YELLOW RIVER WIND FARM

An Bord Pleanála Reference 19.PA0032

RESPONSE TO SUBMISSIONS RECEIVED BY AN BORD PLEANÁLA

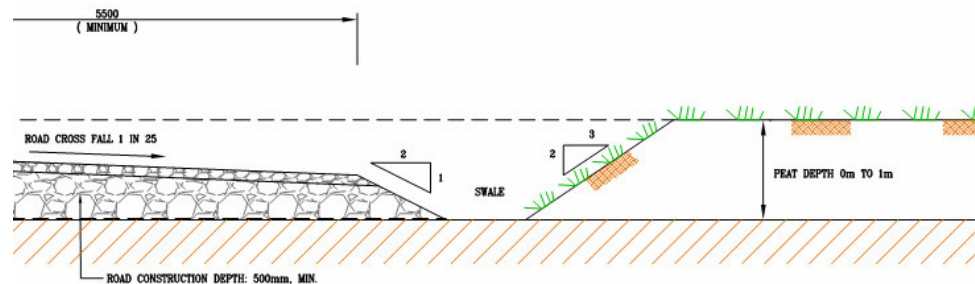
Section 2.9.14 No detail is given for the proposed drainage of this site {-20ha} by swales, e.g. swale dimensions, infiltration rates, attenuation capacity etc.

Runoff from large hardstanding areas such as the site compound, turbine hardstandings, and substation will be attenuated to mimic natural runoff patterns. Attenuation will utilise shallow primary and secondary settlement ponds to aid removal of suspended solids. Calculations for the determination of storage requirements have been undertaken and are as follows:

- A 1 in 100 year rainfall return design.
- The largest hardstanding area of 0.0025 hectares.

The Figure above shows a diagrammatic cross section through this open ditch as it will be when completed.

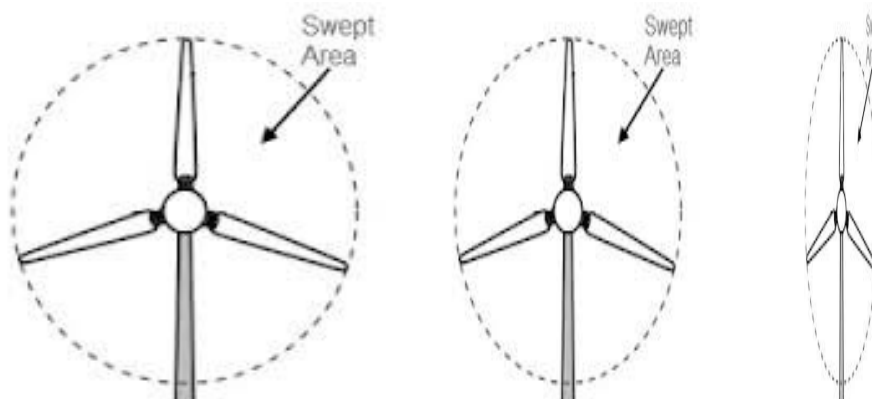
Chapter 10 – Shadow Flicker The applicant should be requested to justify the use of the reduction factor of 61% for non-directional orientation of the turbine. The applicant should also be invited to comment on the requirement in the draft guidelines for no shadow flicker to be experienced at any house within ten rotor diameters.

These areas are a flat projection of the turbine rotation surface area visible from the receptor. When the turbine is orientated at right angles to the receptor the entire surface area is visible. See Figure below. As the turbine turns less of the surface area is visible.

The following turbine rotation surface areas are noted:

9852m ²	<i>Surface Area of Rotor orientated at right angles between the sun and the receptor</i>
8244m ²	<i>Surface Area of Rotor orientated 30% from perpendicular</i>
4398m ²	<i>Surface Area of Rotor orientated 60% from perpendicular</i>
1000m ²	<i>Assumed Surface Area of Rotor orientated parallel to the wind</i>

Figure 1 – TSS Construction monitoring Locations #1

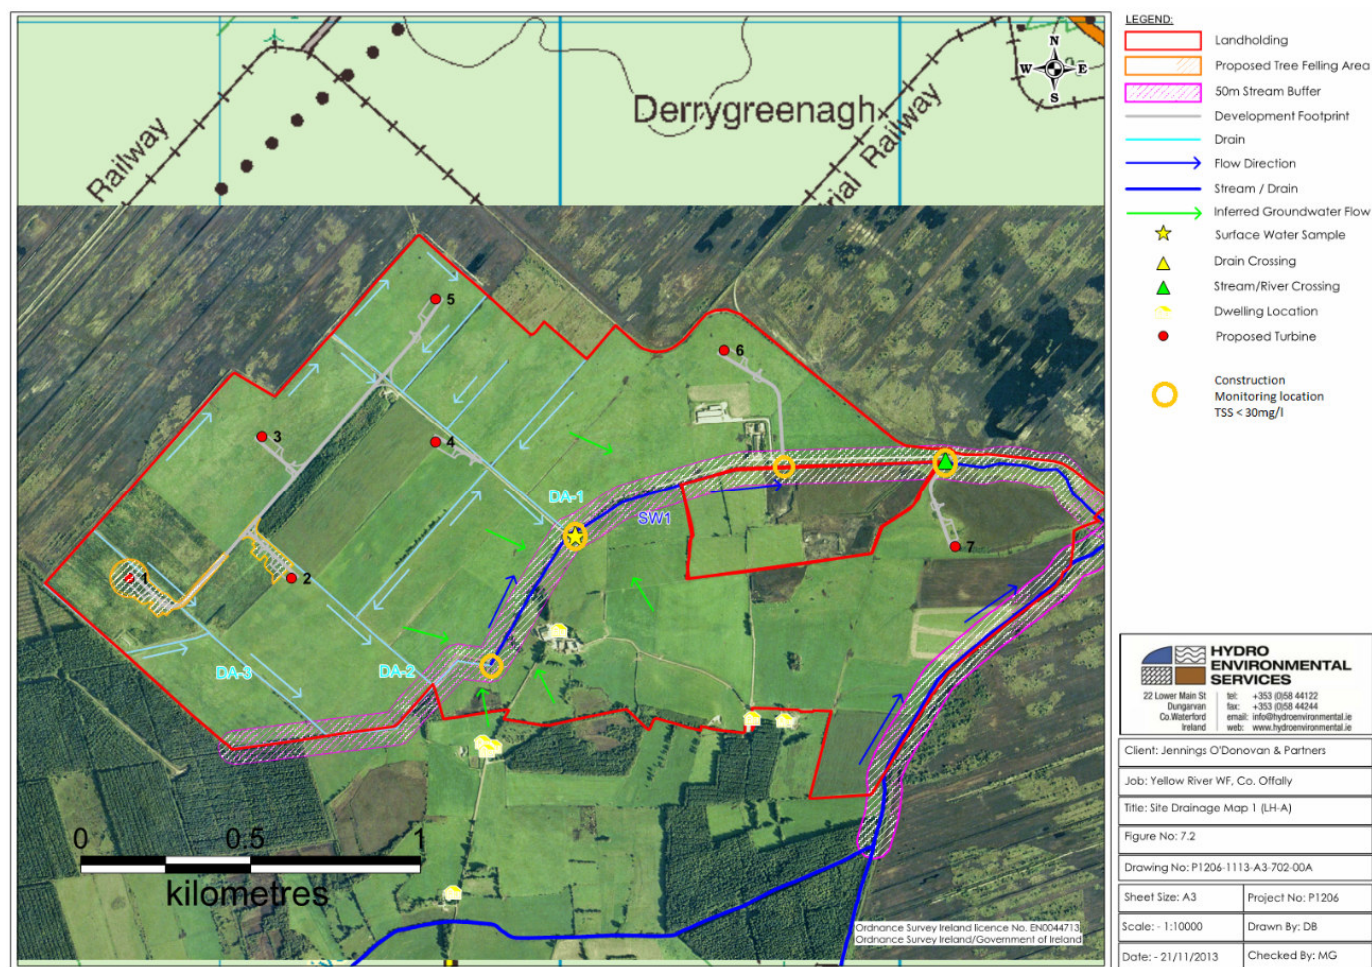
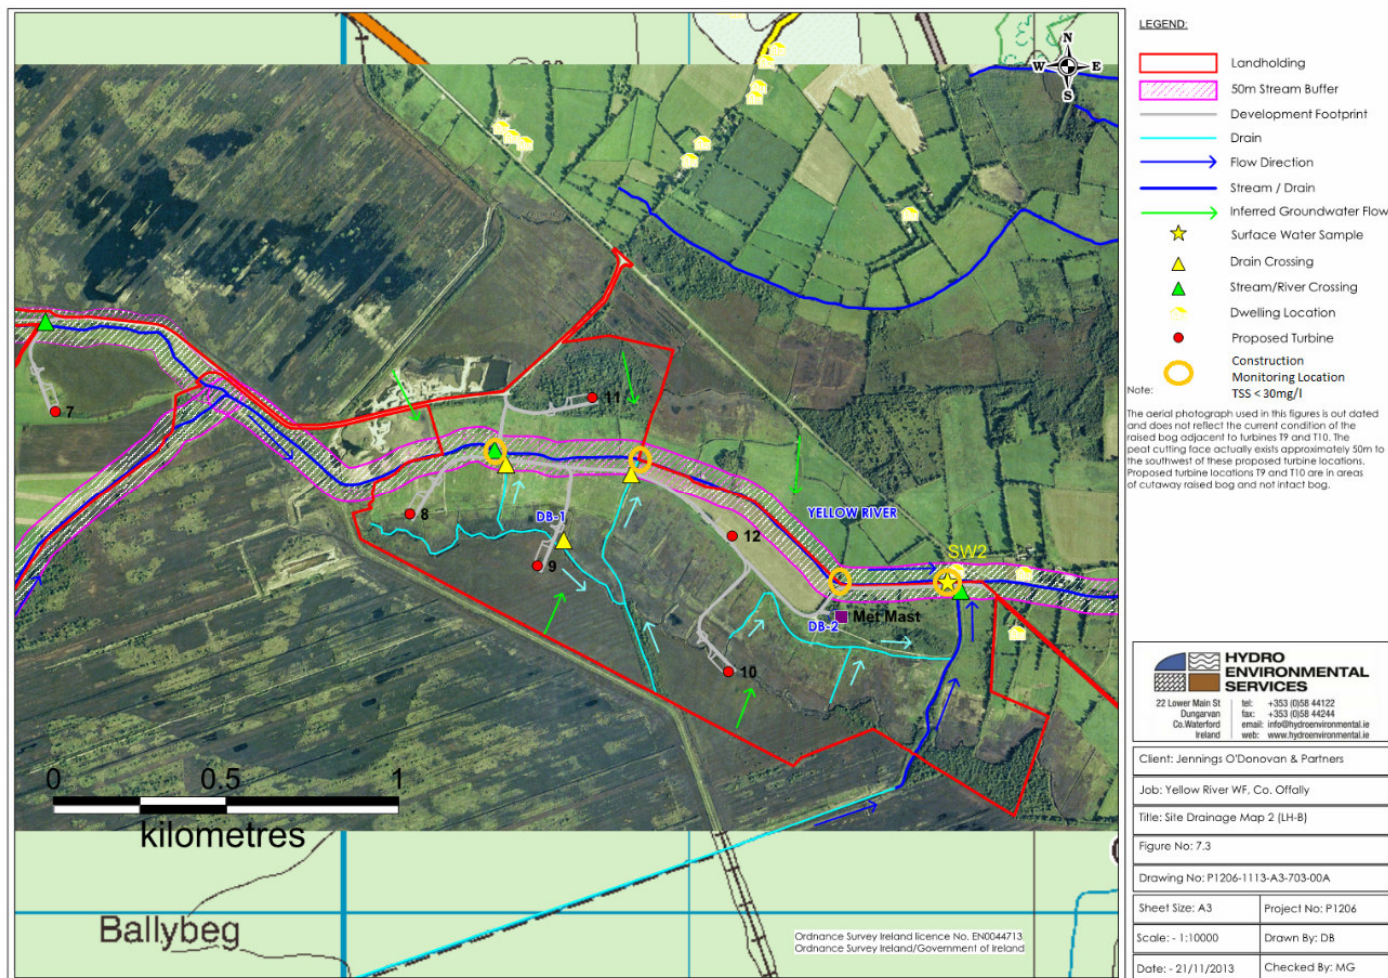
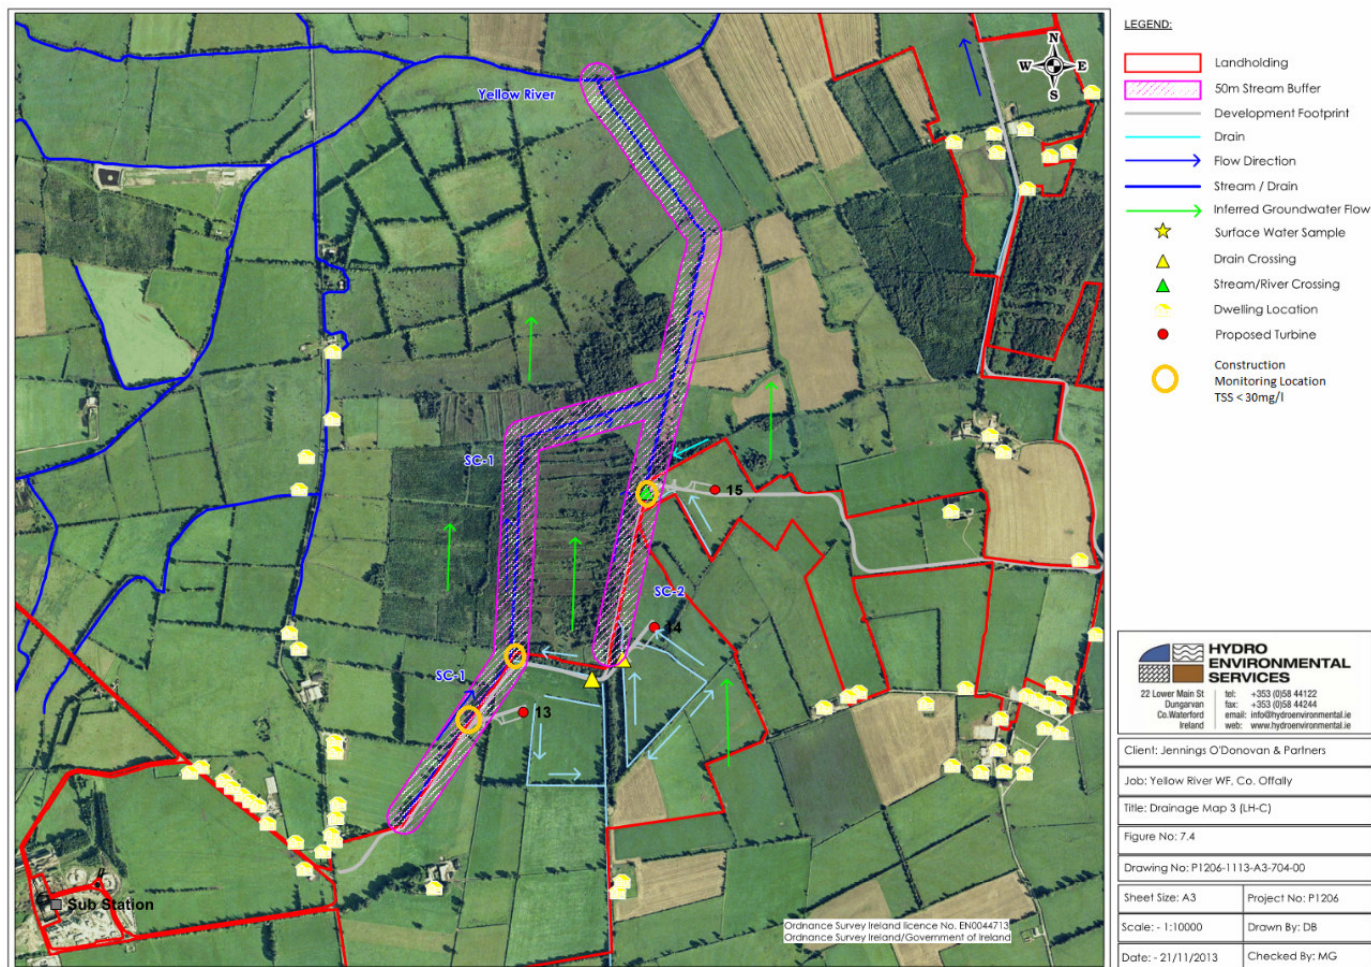
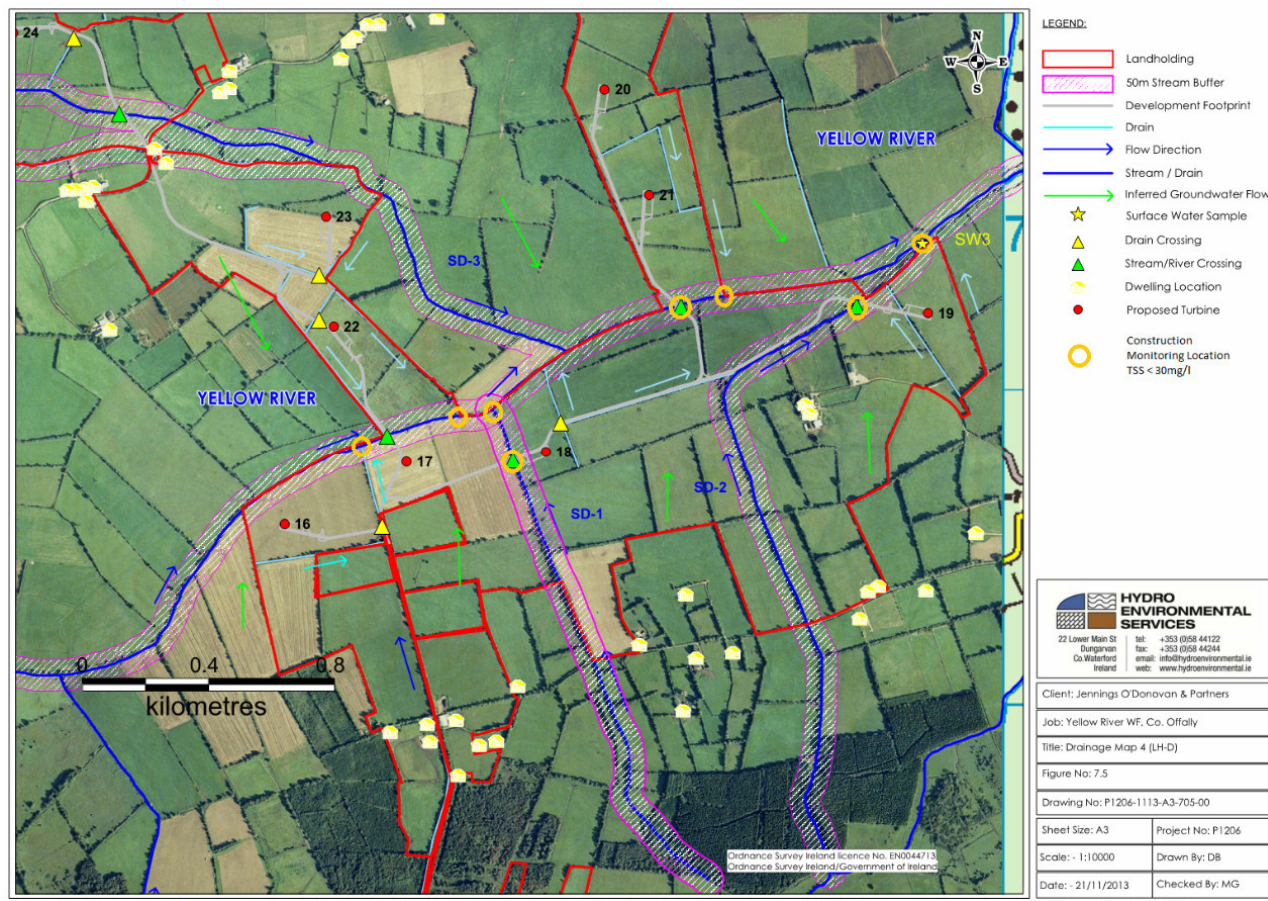
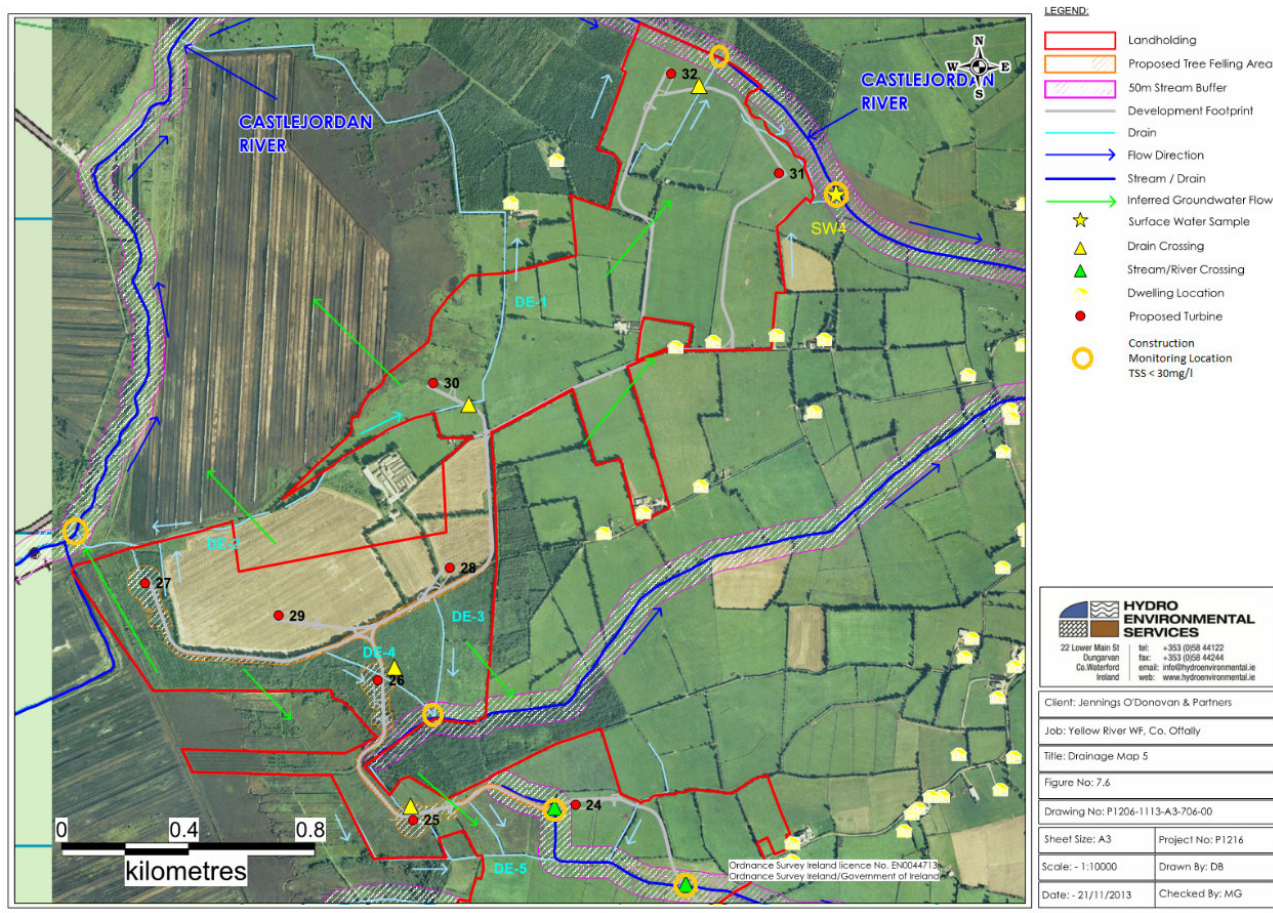
Release of suspended solids to all watercourses should be kept to a minimum. Total suspended solids in discharges should not exceed 30 mg/l in the case of all EPA mapped watercourses (i.e. streams shown on Figure 5.7). This limit should apply to direct discharges to these waters. Non-salmonid drains receiving runoff should not exceed 30 mg/l suspended solids at the point where they join the salmonid watercourses.

If the 30mg/l limit is exceeded, then works within the sub-catchment of the monitoring location will be immediately ceased and will not recommence until TSS levels have dropped below 30mg/l.

The effectiveness of the drainage and mitigation measures will be visually assessed by a competent Engineer and redesigned and adjusted if deemed to be necessary.

Figure 1 – Exponential perceived scale change in relation to viewing distance

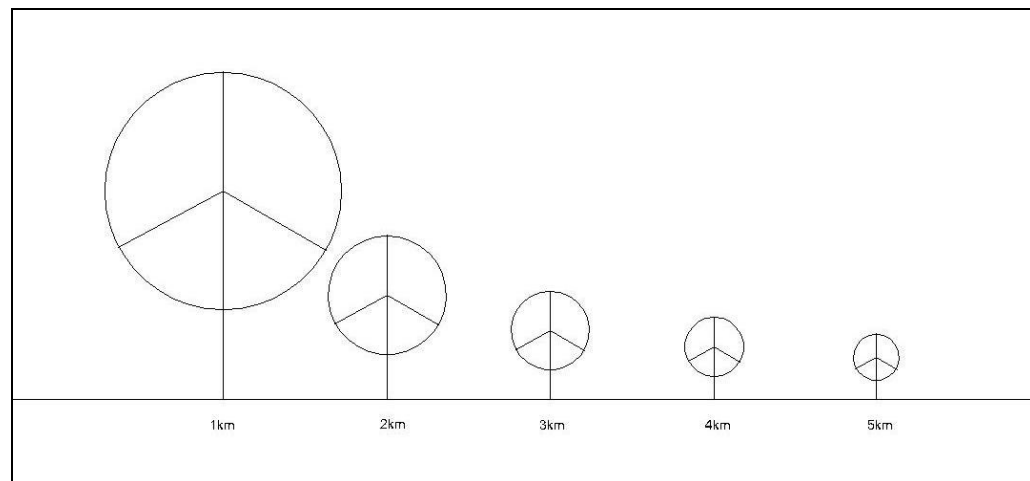
It is considered that the photomontages submitted are not reflective of the significance of this landscape and cultural feature (Croghan Hill), however. It is considered that its local, historical and geological significance requires a much stronger investigation and assessment than what has been given in the EIS. The EIS also states (p. 462) that the Offaly County Development Plan..... “limits protection (of features) to a 2km buffer from wind farm development”. However, the aforementioned 2km buffer (around landscape features, settlements, protected areas, etc.) was a tool in the preparation of the Wind Strategy in 2008. Areas which had fewer or no instances of this buffer were selected as areas where wind energy development might, in principle, be acceptable subject to all other requirements of the plan. Therefore to treat this 2km buffer around Croghan Hill as absolute is not considered acceptable in the context of its significance noted above.

Perceived height of turbines also reduces exponentially with increasing distance because a doubling of viewing distance equates to a halving of perceived height (see figure 1 below). This is reflected in the conclusion of the EIS chapter, which accepts

that the highest level of effects are likely to be experienced within close proximity to turbines (<2km) thereafter the effects fall away quickly due to terrestrial screening and perceived scale reduction. The minimum 500m setback from dwellings and the sinuous linear layout of this development ensures that there are seldom more than a couple of turbines that might be considered to have a dominant visual presence within a particular view. There are also very few locations that afford a view of the entire scheme and where this does occur from the likes of Croghan Hill, the furthest turbines are distant background features.

It is accepted that the moving blades of turbines will draw the eye to a greater extent than static objects. However, these factors are accounted for in the EIS submitted with the planning application because this aspect is considered as part of the visual presence judgement, which in turn informs the magnitude of visual impact.
